Parkview at Aspen Hill, Preliminary Plan No. 120170030

Completed: 6/16/17

STAFF RECOMMENDATION

RE: Preliminary Plan Letter
Preliminary Plan No. 120170030
Parkview at Aspen Hill

Figure 3: Preliminary Plan

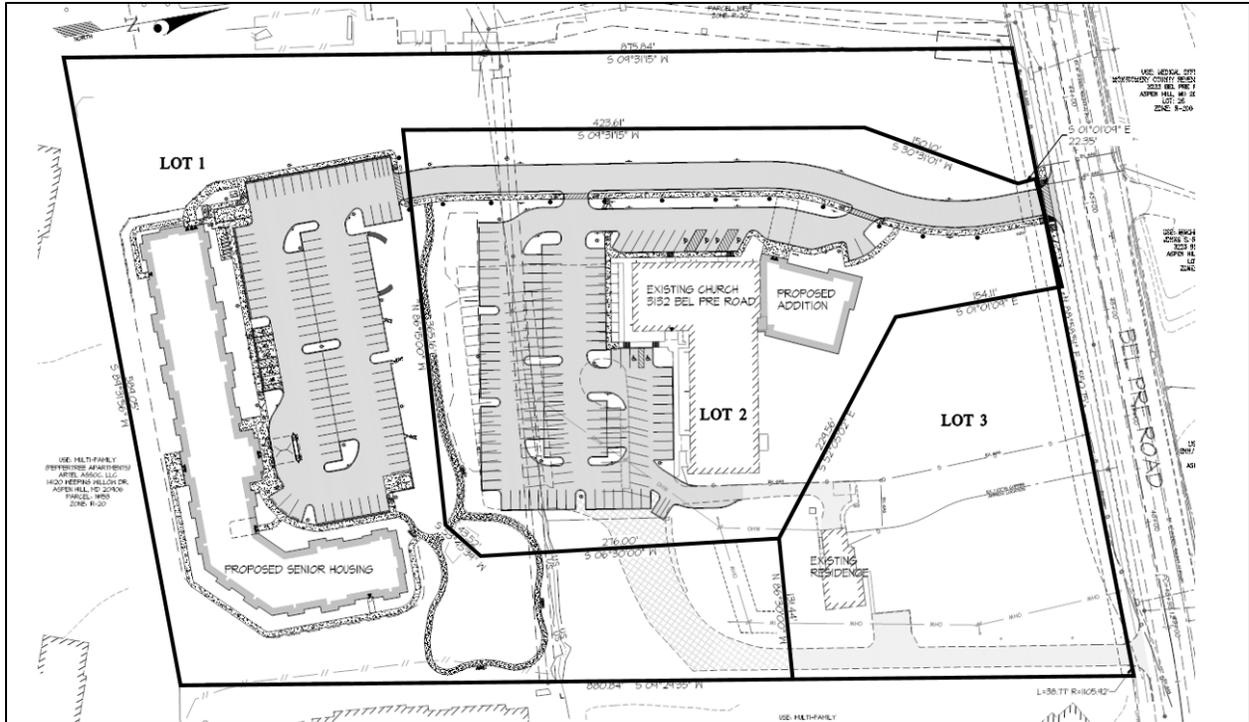
4. Show Homecrest Road on the plan and the distance to the existing driveway.
5. Vicinity map shows Connecticut Avenue as MD-185, however that portion of Connecticut Avenue is maintained by the county. Please revise to delete the reference to MD-185.

6. Label the existing storm drain easement on the preliminary plan.
7. Storm Drain Analysis: The revised storm drain report dated March 22, 2017 has been accepted by Montgomery County Department of Transportation (MCDOT). No improvements to the existing downstream public storm drain system are needed from this applicant.
